Attachment 10 – WAR comments to NRC

NRC DEIS Hearing
PEF Levy Nukes 1 & 2
Crystal River, Florida
Plantation Inn
9-23-10

Executive Summary

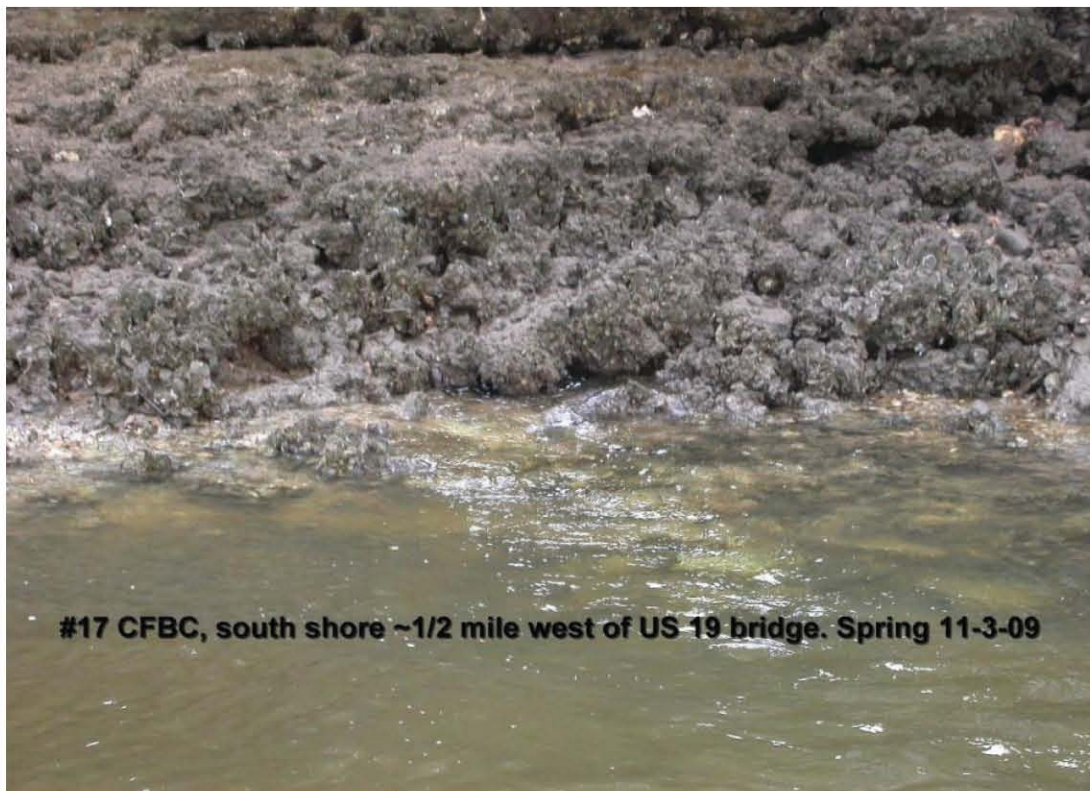
If assertions by the Applicant are correct there is additional spring flow contribution in the CFBC that is unaccounted for by the COLA and DEIS. If the Applicant is incorrect the hydrologic analysis of the CFBC is incorrect and conclusions in the DEIS are not supported. WAR is aware of spring vents visible at low minus tide scenarios that are located west of the US 19 Bridge that crosses the CFBC, or 3 - 5.6 statute miles west of the Inglis Locks. The clustered nature of these features implies that more are present yet unidentified. NRC cannot properly quantify estuarine

The following photos which represent a small portion of approximately 40 spring weeps, cascades and boils located west of the bridge and visible during low minus tides:
